**GOVERNMENT OF THE DISTRICT OF COLUMBIA
DEPARTMENT OF TRANSPORTATION**

MEMORANDUM

SUBJECT: ZC Case No. 16-29 – Columbian Quarter at Poplar Point

Figure 1 – Site Design and Access (Source: Applicant)

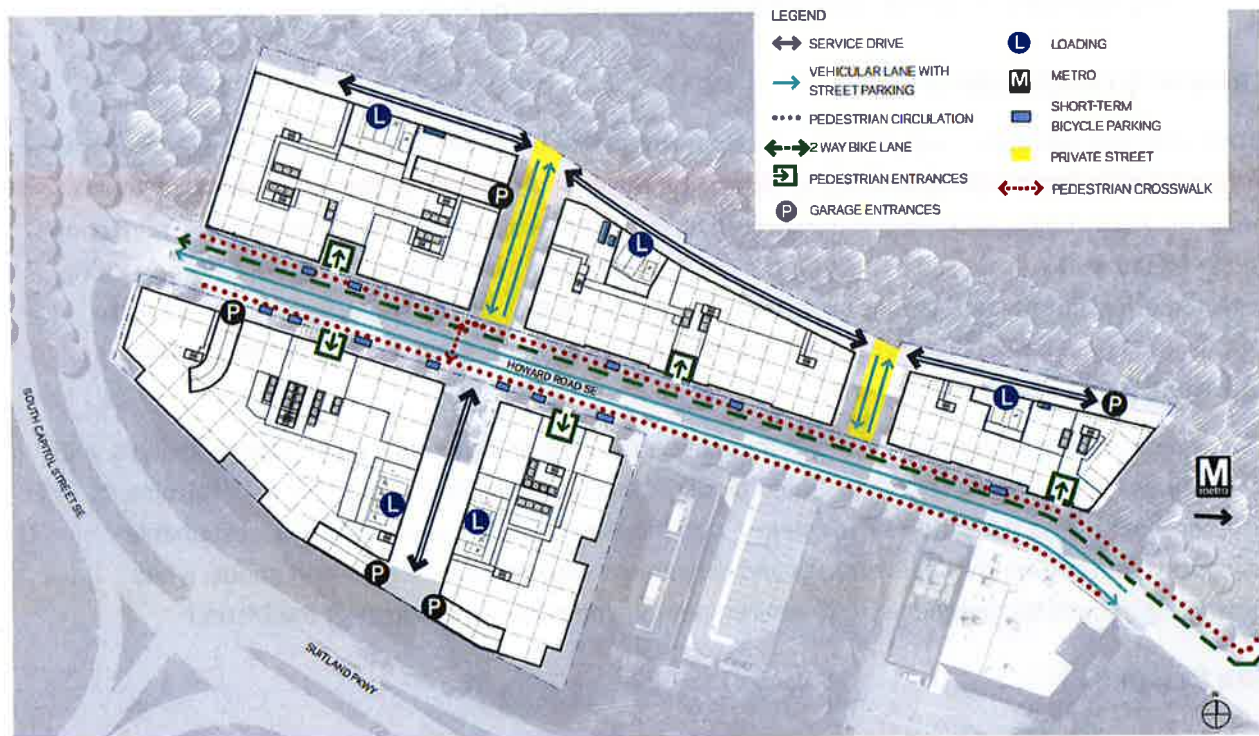
- The proposed driveway on Howard Road for Building D is in close proximity to the adjacent intersection with Suitland Parkway; and
- Loading for the each building is proposed to occur from the private alley and driveway consistent with DDOT standards.

- The proposed driveway on Howard Road for Building D has the potential to create safety problems due to poor site distance and vehicle speeds exiting Suitland Parkway;

The new street network has the potential to disperse site traffic throughout the site in a way that minimizes the action’s impact on the road network in the vicinity. The roads serve as vehicle, bicycle, and pedestrian access points for the site. Furthermore, the new north-south streets set the framework for a robust street network to serve potential redevelopment within Anacostia Park/Poplar Point immediately north of the subject site.

- Implement the following elements proposed by the Applicant but modified by DDOT:
 - Revisit the proposed Howard Road driveway for Building D as part of the Stage 2 PUD, which may result in removal of the driveway or geometric, signalization, operations, or other mitigations to safely accommodate the driveway. DDOT's preference is for all vehicular site access for Building D to be provided via the north-south private driveway between Buildings D and E;

Figure 3 Proposed Howard Road Cross Section (Source: Applicant)

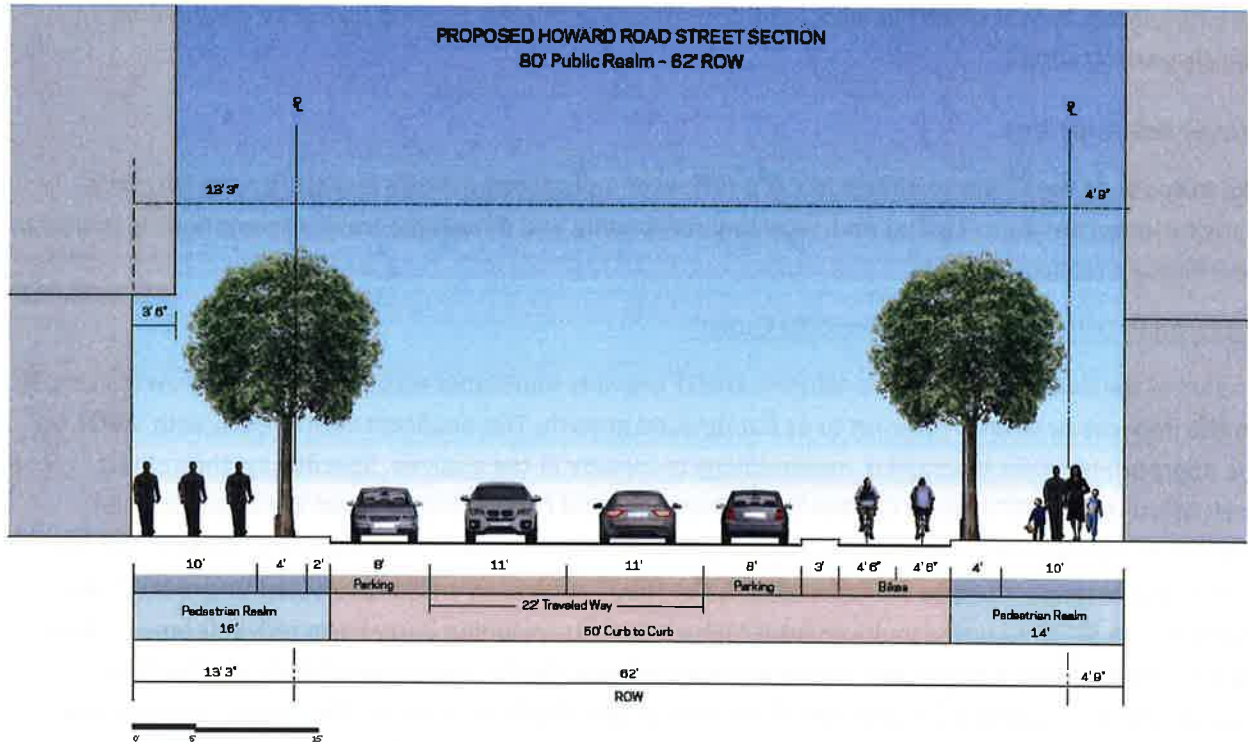
The Howard Road design proposal is shown in *Figure 3*. Of note, the Applicant proposes to accommodate some of the public realm, including sidewalks and street trees, on private space. The public realm will be widened onto private property by 13 feet 3 inches on the south side of the street and 4 feet 9 inches on the north side of the street. On the south side of the street, the entirety of the 10 foot sidewalk and a portion of the tree box/furnishings zone (including the street trees) will be located on private property, while on the north side a portion of the sidewalk will be located on private property. The Applicant is expected to dedicate a public access easement for the sidewalks and furnishings areas.

Within the 62 foot wide Howard Road ROW, the Applicant proposes a 50 foot curb to curb dimension to including a two eight (8) foot parking lanes, two 11-foot travel lanes, and a 12 foot wide cycletrack and buffer. This street cross section provides adequate flexibility to install a center turn lane if approved by DDOT under future conditions (to be determined as part of Stage 2 PUDs for the subject property), which could be accomplished by removing parking on one side of the street, narrowing the remaining parking lane to seven (7) feet, and narrowing the travel lanes to 10.5 feet thereby creating a 10 foot center turn lane.

Careful attention must be paid to the edges of the proposed Howard Road reconfiguration to ensure that the reconfigured roadway ties in to existing conditions to the east and west of the project. In particular, the western terminus of the cycletrack must transition from an in-street cycle track to connect to the multiuse trail to be constructed as part of DDOT's South Capitol Street project. To the east, sidewalks and travel lanes must align with the existing network, and the cycletrack must safely terminate in a manner that provides access to the Metro station and does not preclude future extensions eastward. Howard Road treatment will be refined during subsequent Stage 2 PUDs and final design will take place through the public space permitting process.
